Office Action Summary

10/518,633

DETAILED ACTION

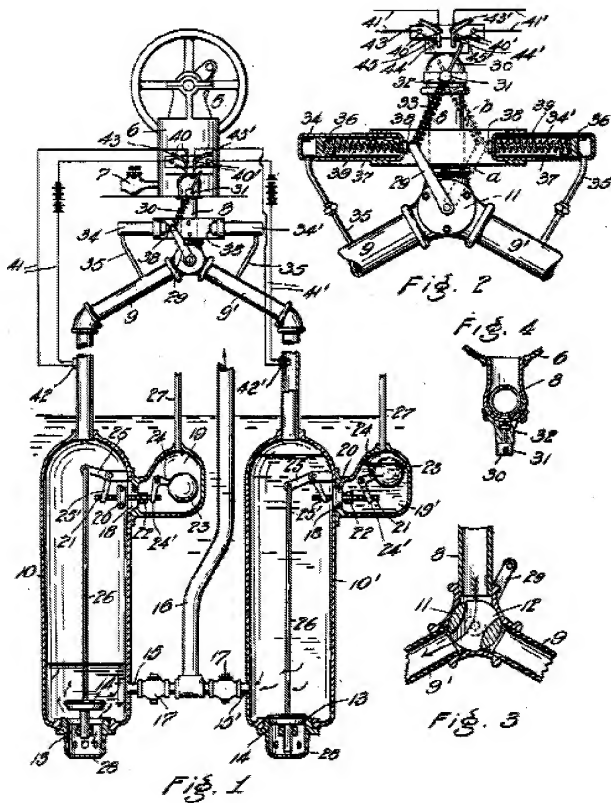
11. In Re claim 1, with reference to Figures 1-4 as depicted above, Emmons discloses a pumping apparatus described as:

- a first container (10) including a pressurisable chamber
- an inlet (13)
- an outlet (15)
- a control apparatus (21,22,23,24,25)
- second container (19)
- pilot valve (20)
- second container (19) receiving liquid from the first container (10) through passage (18) when the liquid in the first container (10) reaches the level of passage (18)
- the pilot valve (20) configured to close the passage (18) and when the float (23) rises in response to the liquid in the second container (19). The closing of the valve (20) triggers a pressurization cycle for the motive fluid that enters through pipe (9). The motive fluid exits through pipe (27) during the depressurization cycle.

14. In Re claim 4, Emmons discloses the second container (19) which is relatively small compared to the first container (10) as depicted in Figure 1.

15. In Re claim 5, Emmons discloses the second container (19) whose base is at a relatively higher location than the base of the first container (10) as shown in Figure 1.

- the apparatus is arranged so that when one pump is discharging fluid, the other is receiving fluid, as depicted in Figure 1.

19. In Re claim 12, Emmons discloses a valve (14) in each first container of the two pumps at the inlet. As depicted in Figure 1, the valves are arranged so that when one pump is charging, the other is discharging.
